ADDENDUM NO. 01 March 19, 2026

RE: Green Barn - Structural & Building Envelope Upgrades **GALE JN: 843180**
 Dorothea Dix Psychiatric Center **BGS: 3748**
 Bangor, ME

FROM: Gale Associates, Inc.
 100 Commercial Street, Suite 410
 Portland, ME 04101

Reference: Drawing S101

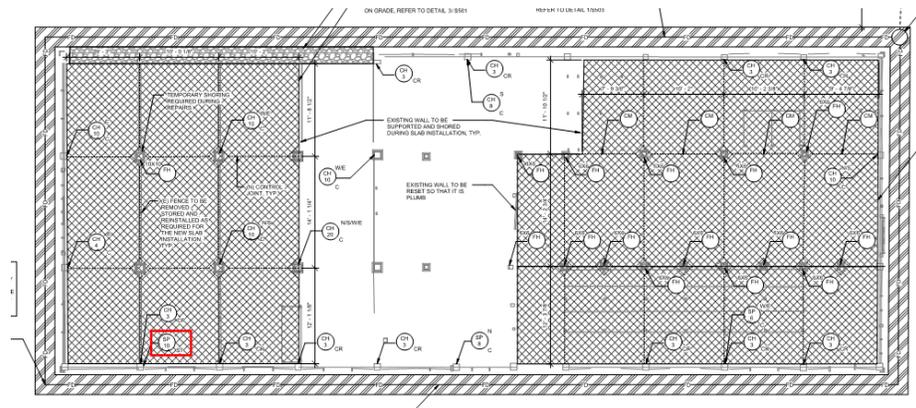
Question: The annotation ST does not appear anywhere on the plans outside of the legend. Please confirm whether and where steel plate reinforcement is required.

Clarification: The annotation “ST” is called out on Sheet S101 one column east from the southwest corner at the SP defect bubble. See screenshot below showing the location of the callout boxed in red.
